#### Addendum No. 003

January 18, 2022

ODOT - Eaton Outpost DOT-200023

ELECTRICAL SITE UTILITY PLAN

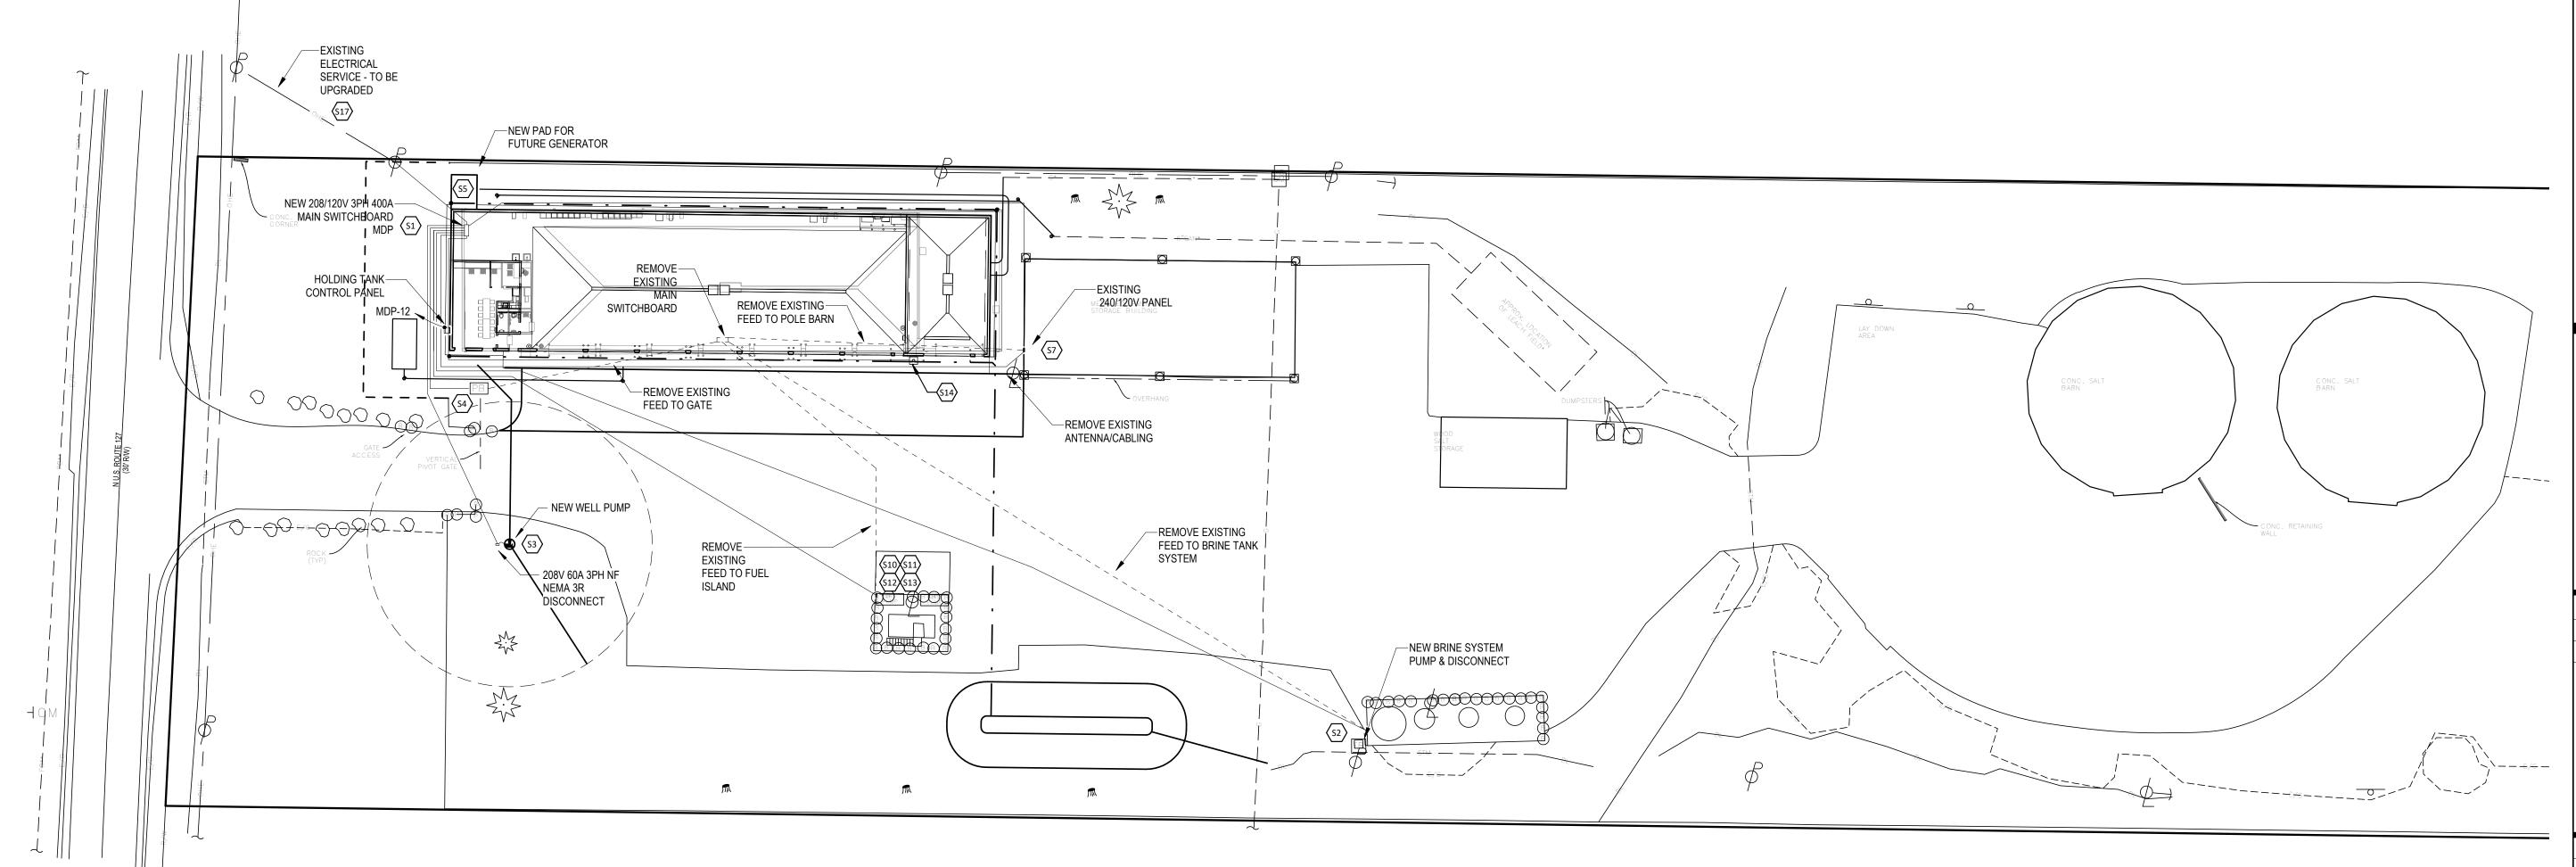
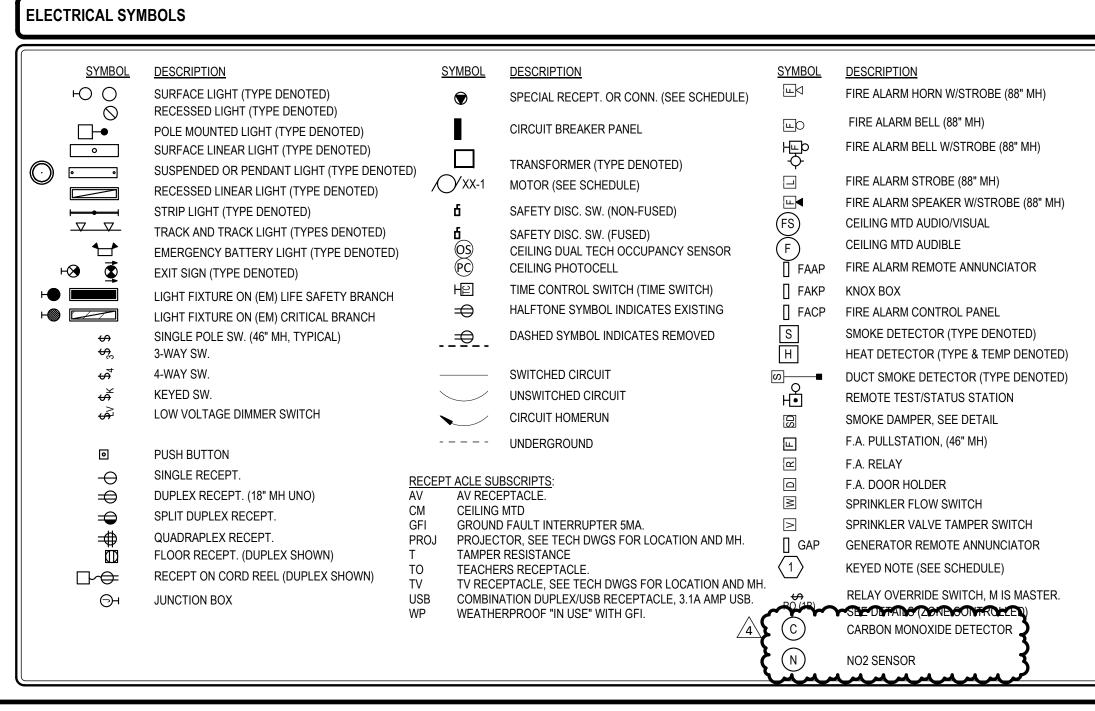
#### Revise Sheet ESU – Electrical Site Utility Plan (Revised Sheet Attached)

Revise Plan Note S1 to underground feed as clouded.

FIRST FLOOR LIGHTING PLAN

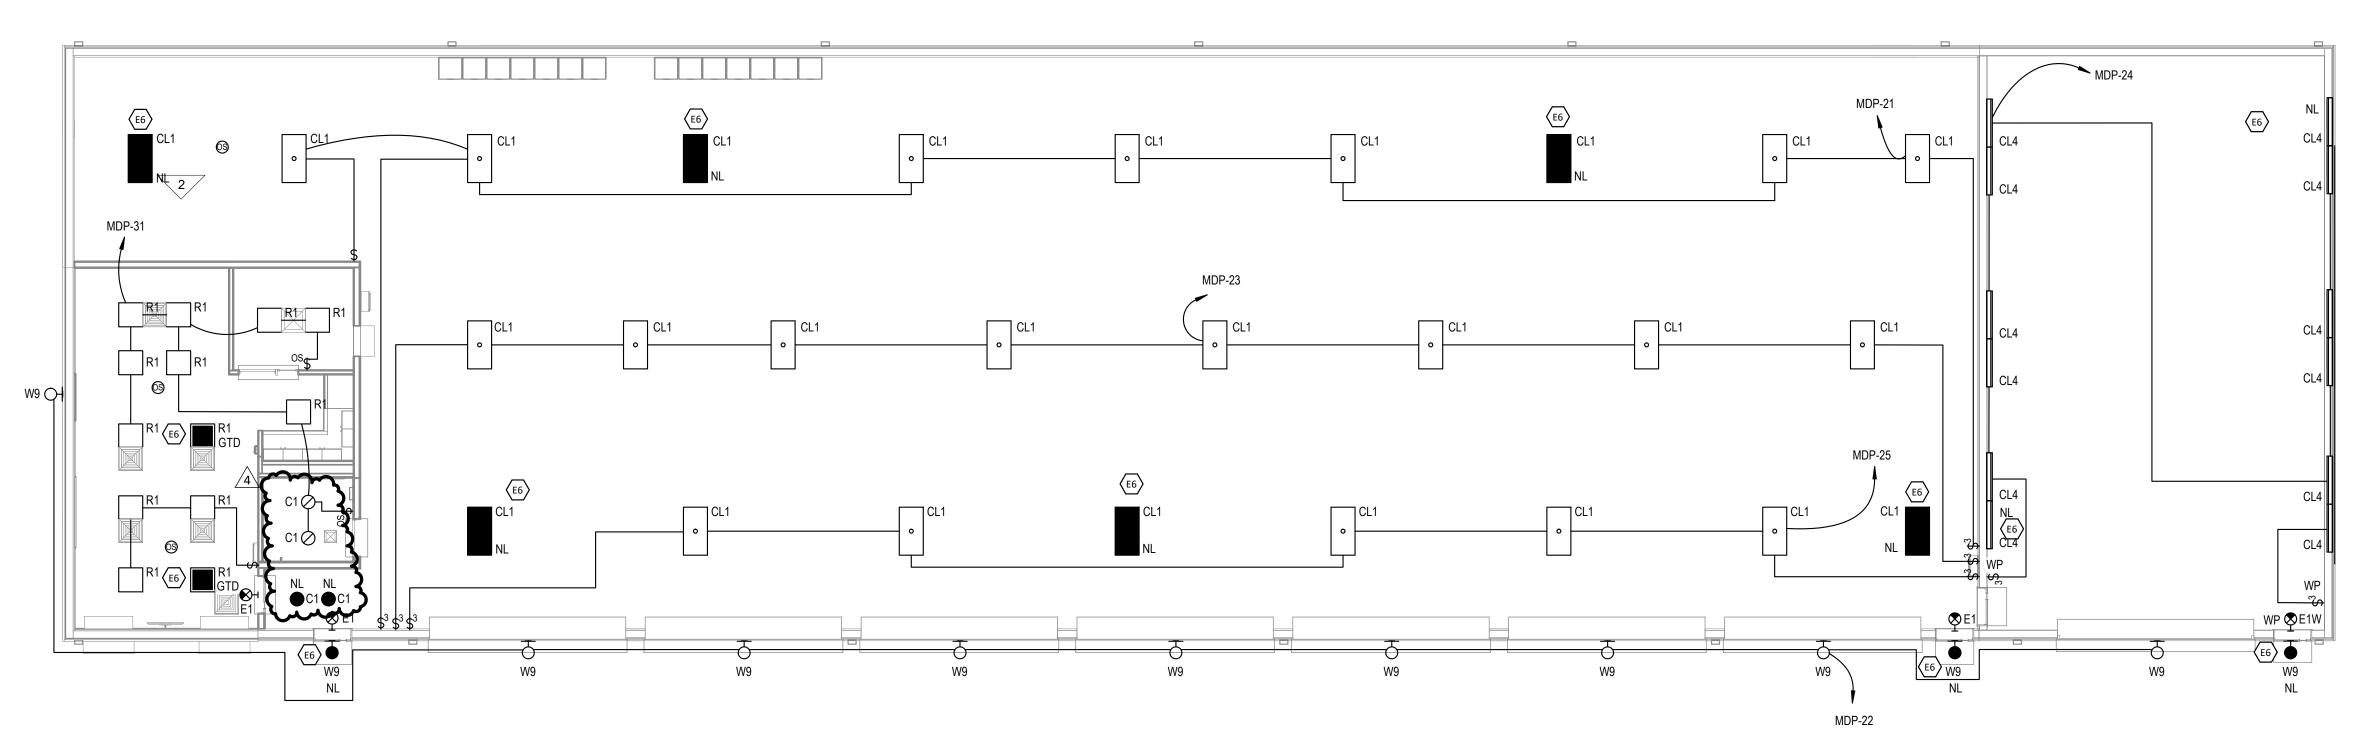
#### **Revise Sheet E101 – First Floor Lighting Plan (Revised Sheet Attached)**

Revise fixture identification to 'C1' as clouded to match Lighting Fixture Schedule.

- **Q6:** Sheet E101 "There is a type R5 light fixture shown but it is not on the fixture schedule."
  - A. This is fixture C1 on the fixture schedule. This has been revised for clarification in the drawings included in this addendum.

FIRST FLOOR POWER PLAN

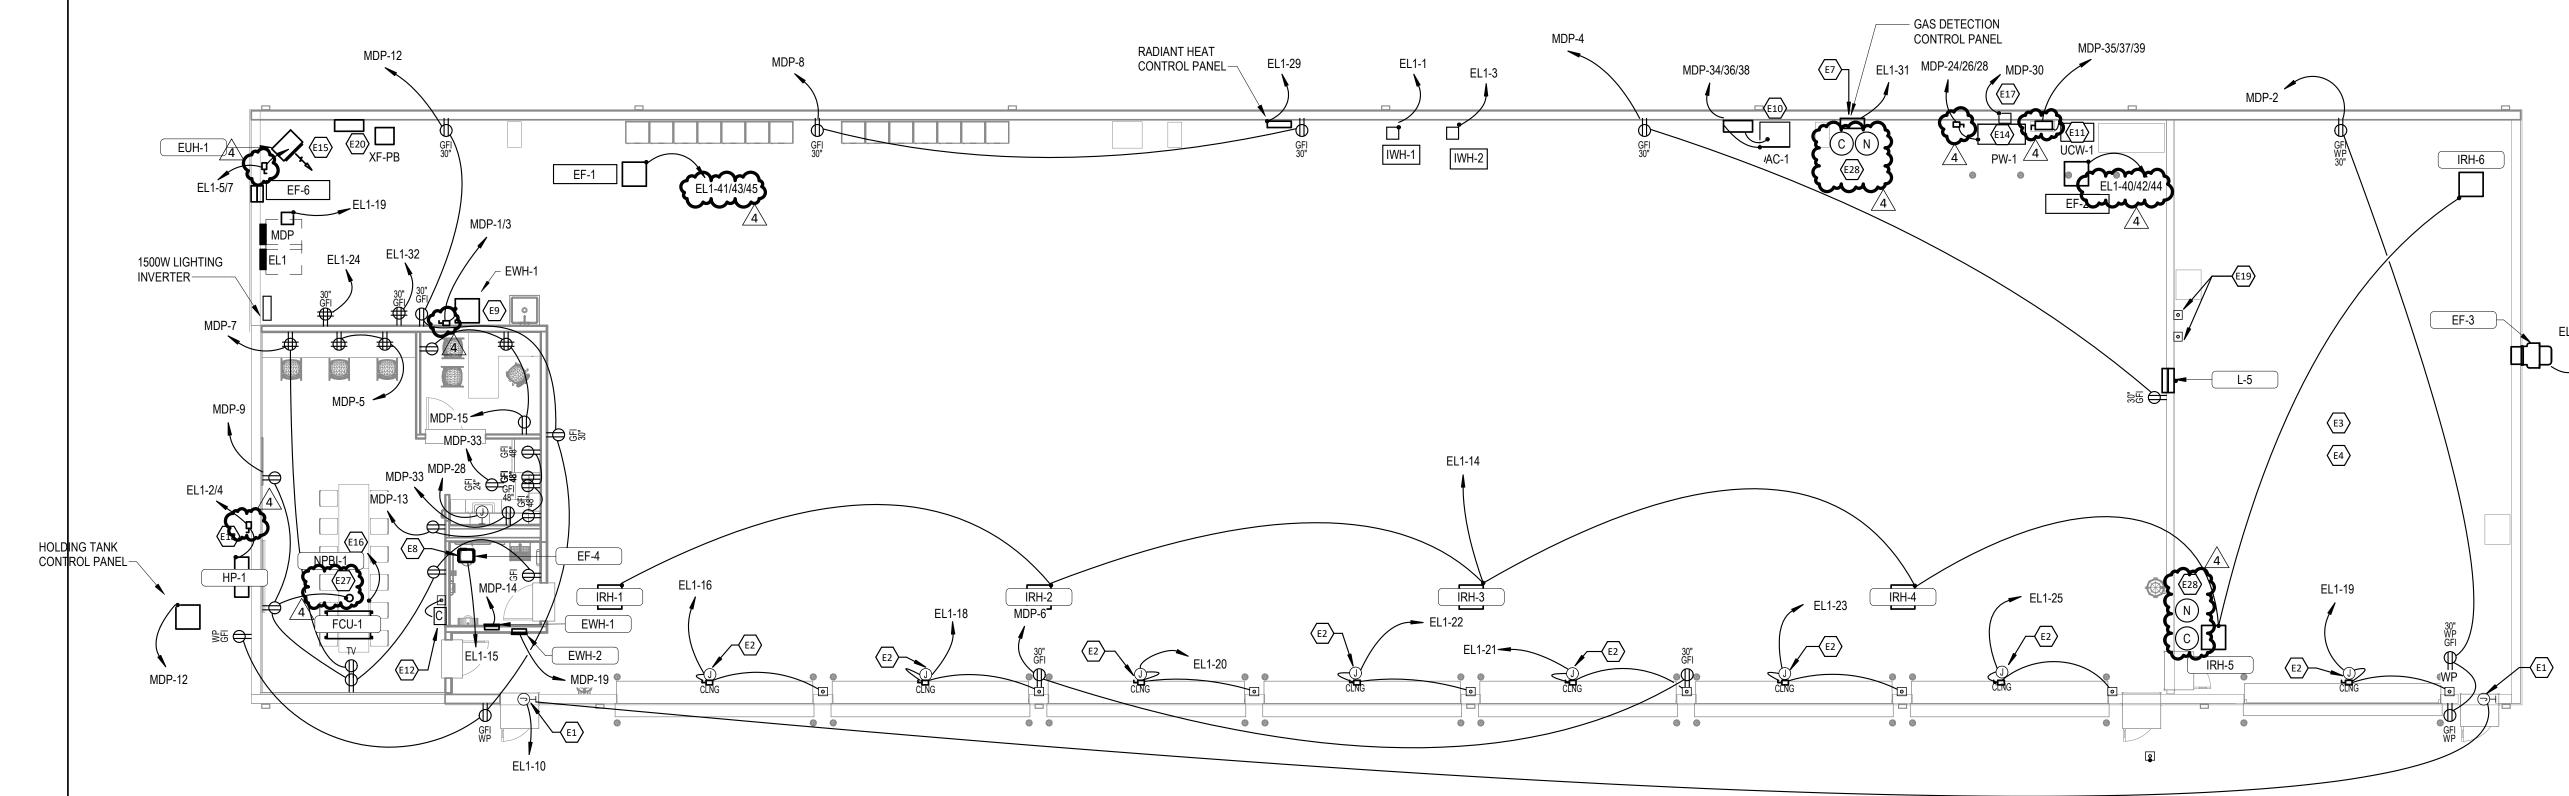
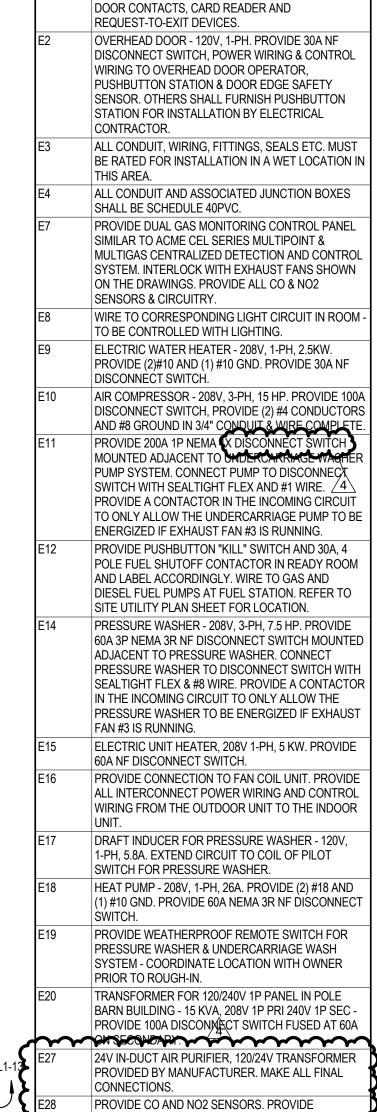
#### **Revise Sheet E201 – First Floor Power Plan (Revised Sheet Attached)**

Add locations for CO and NO2 sensors as clouded.

Update symbology for disconnects as clouded.

Revise feeds for EF-1 and EF-2 as clouded.

Revise Plan Note E11 as clouded.

Add Plan Notes E27 and E28 as clouded.

- **Q4:** Sheet E201 "The disconnect switches on this sheet for various equipment use the symbol for a fused disconnect switch. The notes and one-line call for non-fused. Are fused disconnect switches required?"

- **Q5:** Sheet E201 "Are there locations for the CO and NO2 sensors for the gas detection system?"
  - A. See drawings included herein updated to show locations of CO & NO2 sensors; one of each just inside the wash bay and one of each at the gas detection control panel.

- **Q7:** Sheet E201 "There is a symbol marked NPBI-1. Can this be identified to what this is?"
  - A. This is a 24V in-duct air purifier 120/24V transformer provided by manufacturer. Make final connections. See note H15 on Drawing H101 and revised drawing E201 included in this addendum for further information.

- A. A fused disconnect is only required on the secondary of the transformer feed which feeds the pole barn panel. An updated drawing has been included in this addendum for clarification.
